5.0 REVISIONS TO THE REVISED DRAFT EIR

The following chapter presents corrections, modifications and clarifications to text, tables and figures as presented in the RDEIR. These changes and corrections have been initiated by City of Petaluma staff (as Lead Agency), and/or have been made in response to public comments received on the RDEIR. Changes include revisions warranted or required to ensure accuracy and clarity of the environmental analysis. These changes made to the RDEIR constitute information that clarifies or amplifies or makes insignificant modifications to the adequate RDEIR (see *CEQA Guidelines* § 15088.5b). As such, the following changes do not require recirculation of the RDEIR.

As indicated in the Introduction to this document, the entirety of the Scott Ranch Project Final EIR consists of the RDEIR and its appendices, and this Response to Comments document. Thus, changes to the RDEIR presented below supersede the corresponding original text of the RDEIR. Throughout this chapter, newly added text is shown in underline format, and deleted text is shown in ~~strikeout~~ format. Changes are listed in the order in which they appeared in the RDEIR (e.g., **Chapter 1.0,

UPDATED FIGURE 5.0-1

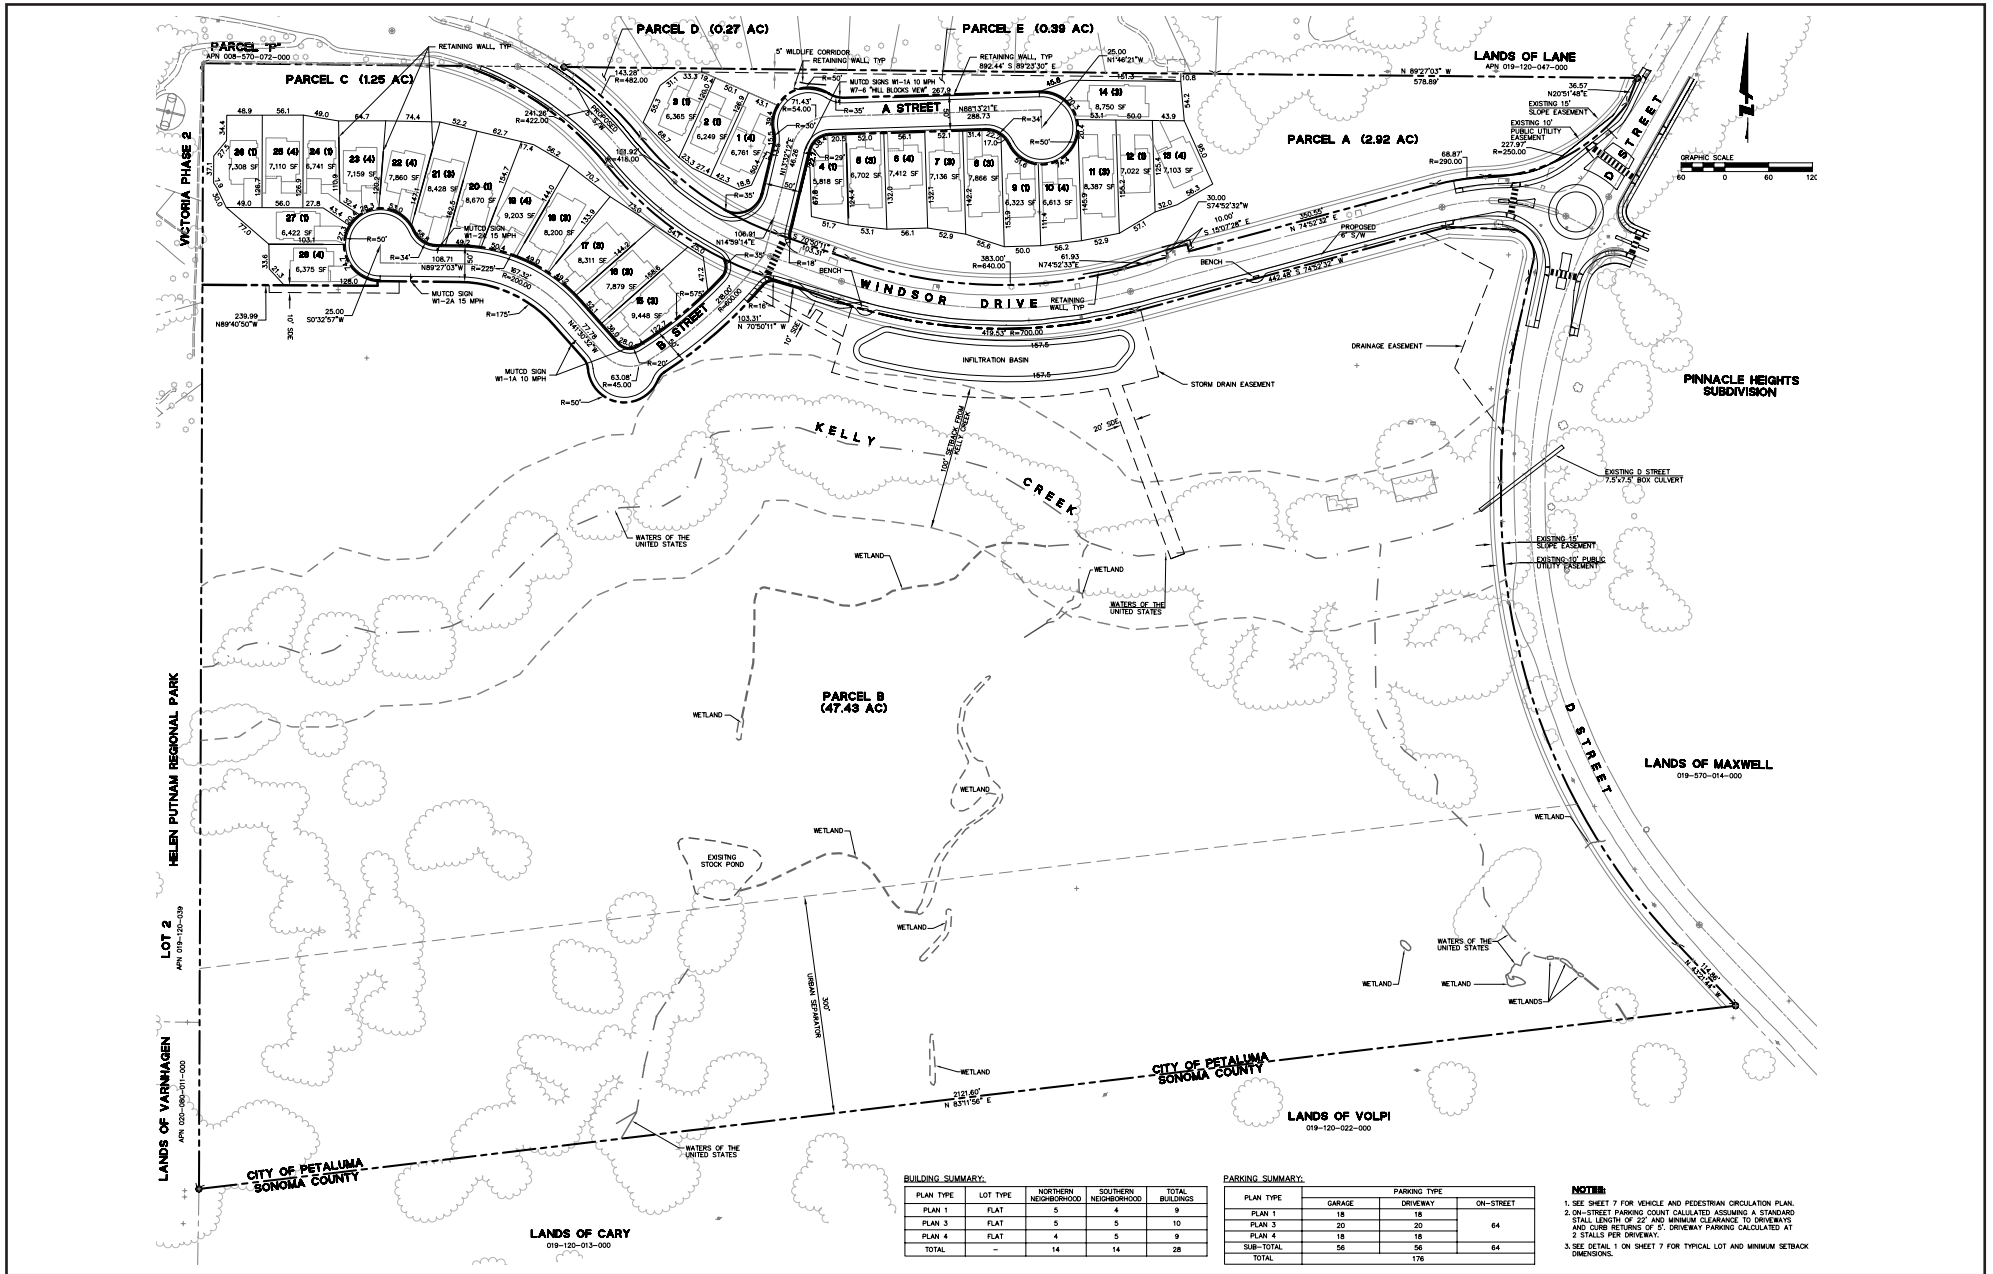
Figure number has been updated as follows: **Updated Figure 5.0-1**

Figure has been updated to show the revised footprints of Alternative 2 that reflect the revised residential component as updated in Chapter 3.0, Project Description.
